Re: Bear Creek Vistas - preliminary plat (Case #15-216)

**AGENDA REPORT
PLANNING AND ZONING COMMISSION MEETING
October 22, 2015**

A request by Jerry D. Kelly (owner) for a 3-lot preliminary plat of R-1 (One-Family Dwelling District) zoned land to be known as "Bear Creek Vistas". The 5.02-acre subject site is located on the east side of Creasy Springs Road, approximately 200 feet north of W Prairie Lane, and includes a home addressed 3628 N Creasy Springs Road. (Case 15-216)

PRELIMINARY PLAT
BEAR CREEK VISTAS

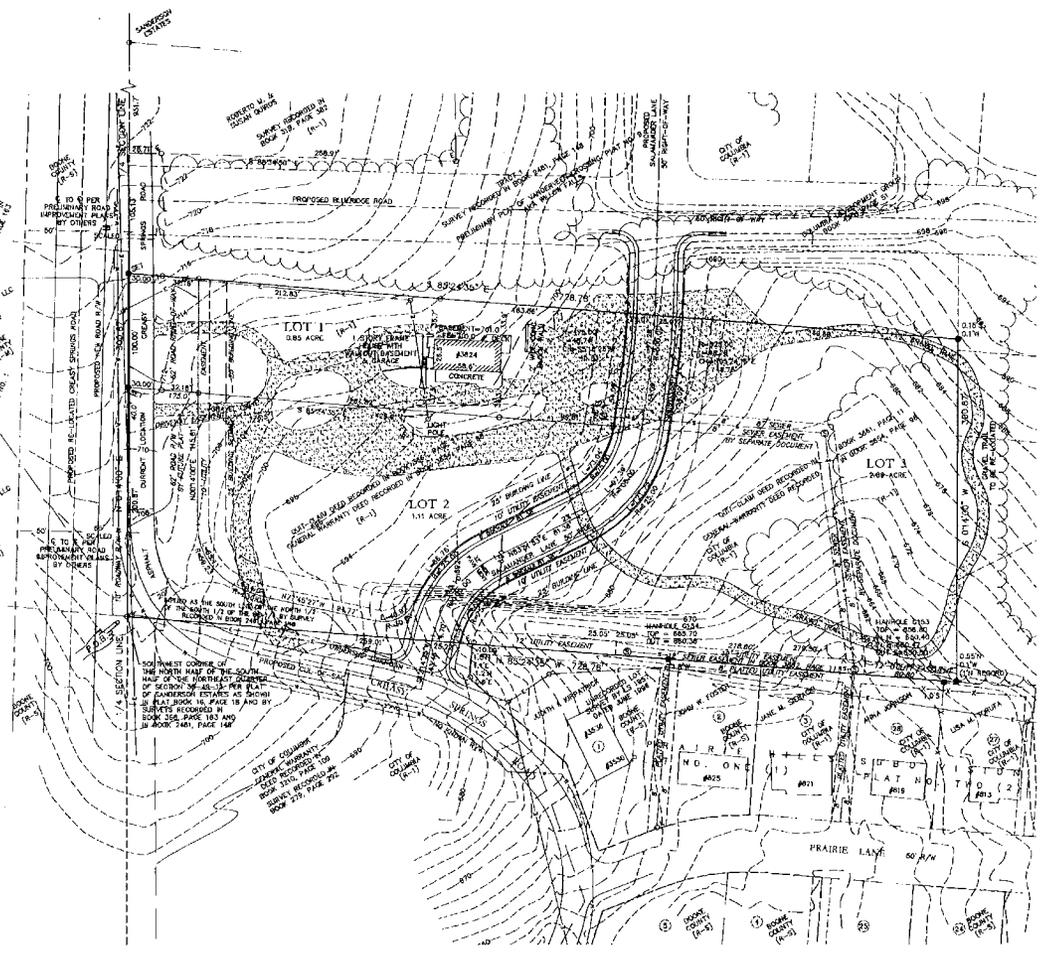
MS. LOE: During phase two, when Lot 2 is developed, where will the City require the sidewalks to be installed?

MS. LOE: But you would not require Lot 2 to install a sidewalk along Creasy Springs?

MS. LOE: Well, that sort of segues to my second question, which there's a pretty significant drainage ditch. It's more significant as you head down the hill, but there's a drainage ditch to the east side of Creasy Springs. Are you anticipating that the sidewalk be located between the road and the ditch or to the east of the ditch toward the applicant's house?

MS. KIRKPATRICK: My question is why the connector is being connected to Creasy Springs right on that curve that has so many dangerous -- I see lots of accidents there -- lots of accidents. It's a very dangerous curve. And so why are you putting a connector down to that dangerous area rather than making them go up to Blue Ridge, which is a much -- going to be a much safer place for people to enter Creasy Springs?

MS. KIRKPATRICK: Well, then I'm back to my original questions. Why would you have that connector come out to such a dangerous spot on Creasy Springs?

MS. KIRKPATRICK: No. I'm just saying why would you even connect right there on that hill. The traffic from the new subdivision phase two should go up to Blue Ridge Road and over to a much safer spot.

MR. MACINTYRE: With phase two, there would be a requirement for sidewalks along both sides of the new residential street.

MR. MACINTYRE: Absolutely. So there would be sidewalks along both sides of the residential street, including the east side of Lot 1.

MR. MACINTYRE: We would if it's still there, and I believe it would be, but I don't know the timing

MR. MACINTYRE: On both. On Lot 2, I'm really not sure what the situation would be as far as the grades go. The sidewalk on Lot 1 would be pretty much at grade on the east side of the ditch between -- so it would not be between the ditch and the road. It would be --

MR. MACINTYRE: Yes. The connector residential street that would come with phase two would be connecting to Creasy Springs at a point where Creasy Springs is no longer connecting here, so this portion of Creasy Springs would be possibly even renamed and it would be serving as a residential connector at that point. So the final connection of the street through the site would be probably not opened until such time as it's safe to do so, so it may actually be delayed. I'm not sure about that, but -- until Creasy Springs is realigned. Another hinging element is having the future or assuring the future connection of -- to Blue Ridge Road here, and the timing of developments, final plats, which seem to be heading westward from the existing Vanderveen Subdivision and neighborhood would be the ultimate determining factor for that. I think we -- we could probably see one or two more phases of Vanderveen or Willow Falls, as they're calling it, in the latest final plat before they reach the point to where this stub to the north that will be necessary to connect to Blue Ridge Road would enter into potential completion.

MR. ZENNER: Ms. Kirkpatrick, I believe -- I understand your question and I believe Steve does, too, but we're having -- just a disconnect. The segment that would be required as part of the construction of phase two will require the City's traffic engineers to approve that connection to the existing alignment of Creasy Springs. If, at that point, it is determined that sight distances and traffic safety cannot be -- cannot be assured, our traffic engineers potentially could have the applicant that would be developing the remaining portion of this property not make that connection, thereby Lot 2 and Lot 3, which are in phase two, would have to go north to Blue Ridge until such time that we could complete the connection of the connector roadway to the capped existing Creasy Springs once the new alignment is constructed. But until we know the pattern and the approach of the development coming from the east out of Willow Falls, it's very difficult for us to say what will or what will not happen. What our traffic engineers, however, will have to verify at the time that this comes in is can that intersection be adequately constructed to meet sight visibility and safety standards. If that can't be done because of what is happening here along the southwest corner of the property, it is possible that we, as a city, may take action to not have the road connected. But, ultimately, when the road is capped as it's shown in this diagram and the new alignment is built, the flow of traffic between this small connector is basic to allow folks that are either in the Prairie Lane Subdivision or property that's to the south to be able to circulate back up to Blue Ridge without having to come all the way back over to Creasy. There's factors that are in play that we can't speak to as to will this connection be made when phase two is developed. It may or it may not be. If it's developed as

MR. MACINTYRE: Well, I think long-term, it is needed. It's desired for connectivity, as I mentioned, through the residential neighborhoods or between the residential neighborhoods. As Pat mentioned, the -- the safety concerns, and I apologize for being dense when it came to your initial question there, but I think I understand what you're getting at now, is as it relates to the existing conditions of Creasy Springs Road, if this were to open, you're saying that it would be a potential cut-through, and a safety concern to have a new street enter in on that dangerous curve where -- where it serves as a through major thoroughfare currently. And so Pat mentioned, of course, that the requirement or conditions of opening that segment and the timing of opening that segment would be dependent on safety assessments by our traffic engineers. The reason that we want the entire section of this street to be built with phase two and we want phase two to be -- to complete out the development that we're discussing tonight is to ensure that it -- that the street is constructed on the property. What we see in many subdivisions is a phasing of development that goes one lot at a time or completes all of the lots up to a point where one or two lots remain at the far end where it would be connecting -- you know, where it shows a connection that perhaps the developer isn't interested in making, and then they leave that and it never, ever gets connected because they don't ever finish out the plat. So in this case, we want to ensure that the potential exists for that street to become usable at such time that it's appropriate and safe to do so. So your point about timing is -- is well taken. I acknowledge that. I'm sorry it took so long for me to understand what you were saying, but -- but that would be certainly something that our traffic engineers would assess the safety of if the timing worked out so that the street was in place prior to Creasy Springs being relocated and cut off.
